Revision History

Schematics taken from P151-A00-X24 MS-8889 00A

NVIDIA Corporation 2701 San Tomas Expressway Santa Clara, CA 95050, USA								
	NVIDIA	Top	Page	P151						
		Size CAGE Code	DWG NO		Rev					
A03		Custom		P151-A00-X04						
A03	Friday August 02 2002	Scale	1	Sheet

3.g DACB(A)/VGA-DB15 Connectors

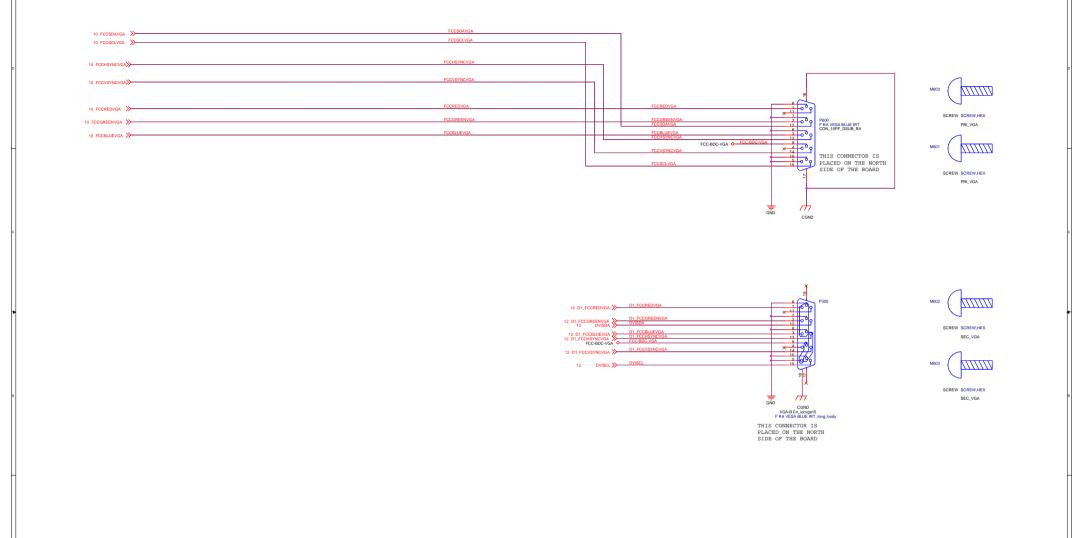
```
00A-0621
1)Page 10,13,18 of the original design (P151) has been delete.
2)Page 10,12 U816,U817,U818,U811(single gate) share one ACT08/SO8.
 3.Page 13 a.P300 change reference to P600.
            b.Add P300 (long D-sub)for SEC D-sub.

1)Page 17 - C2234 change to 2.7nF. 2)Page 15 - Add JP2 connector to "DVOD21 and GND. 3)Page 13 - P300 pin 17,18 floating.
